**ADDENDUM #5**

**T-20-122**

**FOR: Construction of a New Elevator and 2nd Floor AODA Washroom**

ELECTRICAL ADDENDUM NO. E-002 R1

E001

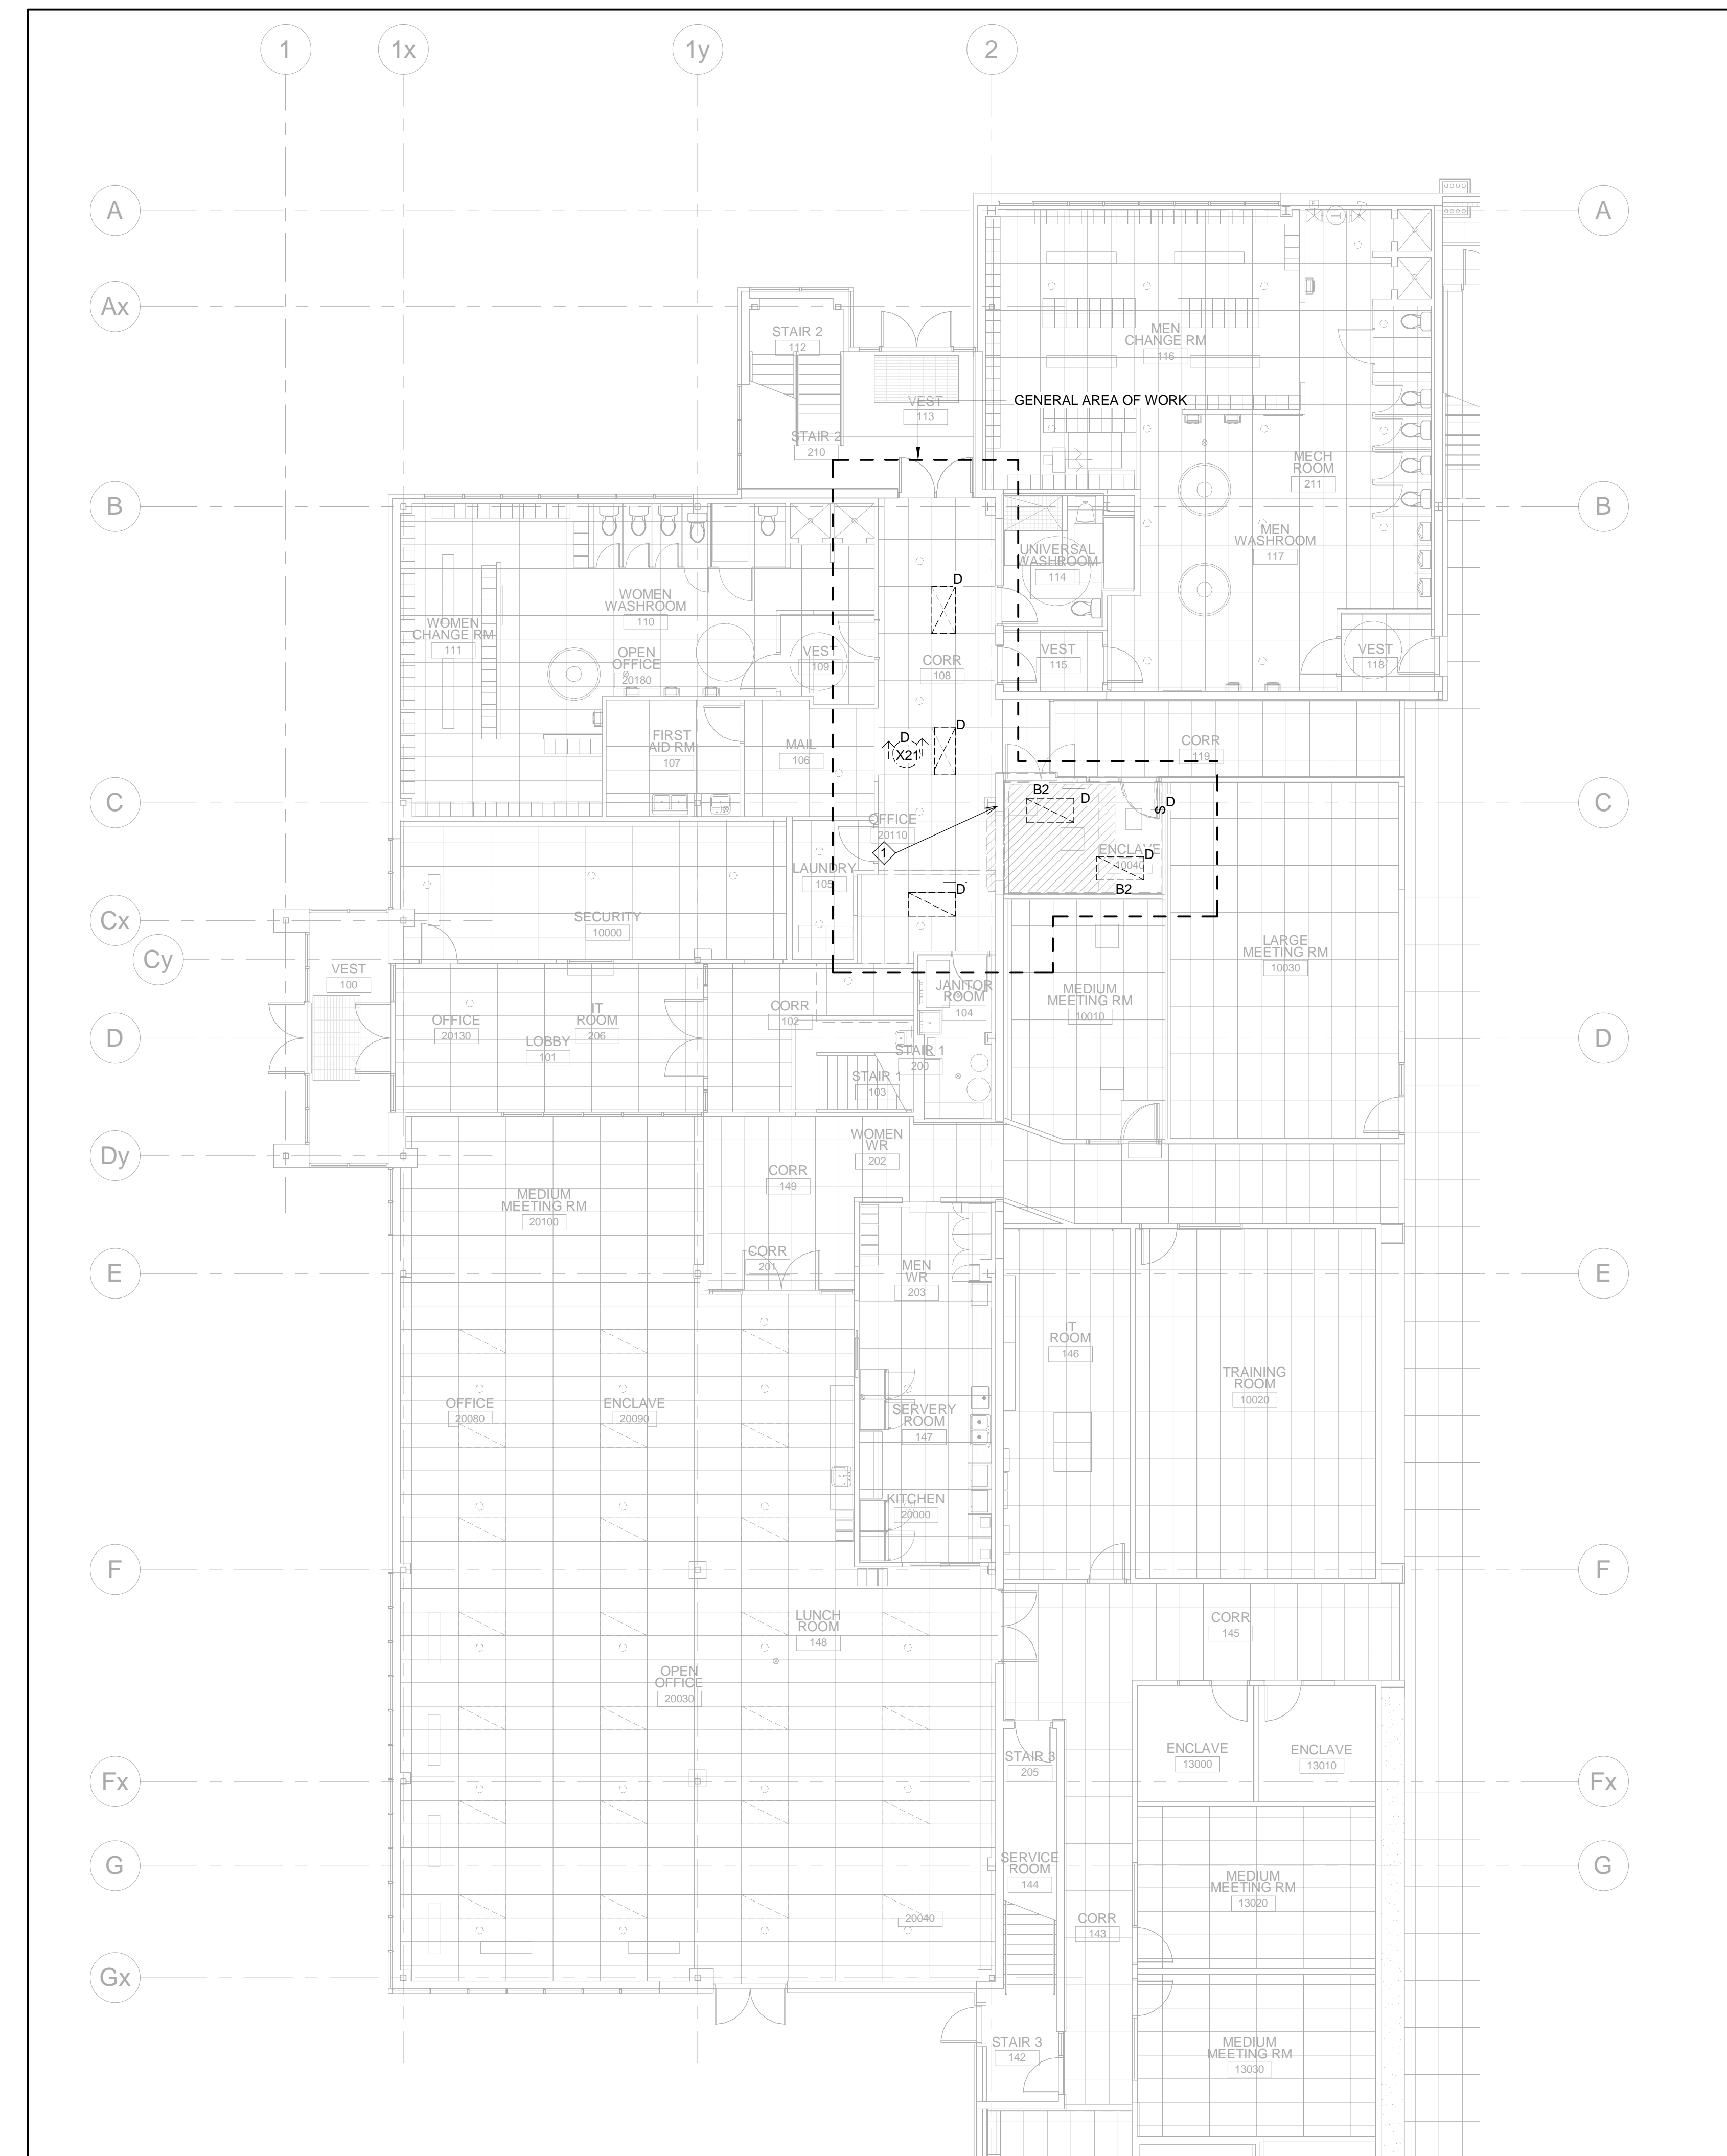
**Q13.** The luminaire schedule do not show the specifications for Type 'LB1'. Please provide specs

- a. Drawing E001 – Electrical legend, notes and Lighting fixtures schedule
  1. Lighting fixture schedule has been updated.
- b. Drawing E100 – Ground Floor-Lighting layout
  1. Exit sign types have been revised.
- c. Drawing E101 – Second Floor-Lighting layout
  1. Exit sign type X11 has been deleted.
  2. General notes have been revised.
- d. Drawing E200 – Ground floor-Power and Systems layout
  1. Circuits have been revised.
  2. Type of data drop located on the west wall of Enclave room 10049 has been revised.
  3. Breaker and Feeder sizes for hydraulic elevator have been specified.
  4. Keynotes have been revised.

**A13.** See attached revised drawings.

- 1.1 E001 – Electrical legend, notes and Lighting fixtures schedule
  - 1.1.1 Lighting fixture schedule has been updated.
- 1.2 E100 – Ground floor-Lighting layout
  - 1.2.1 Exit sign types have been revised.
- 1.3 E101 – Second floor-Lighting layout
  - 1.3.1 Exit sign type X11 has been deleted.
  - 1.3.2 General notes have been revised.
- 1.4 E200 – Ground floor-Power and Systems layout
  - 1.4.1 Circuits have been revised.
  - 1.4.2 Type of data drop located on the west wall of Enclave room 10049 has been revised.
  - 1.4.3 Breaker and Feeder sizes for hydraulic elevator have been specified.
  - 1.4.4 Keynotes have been revised.
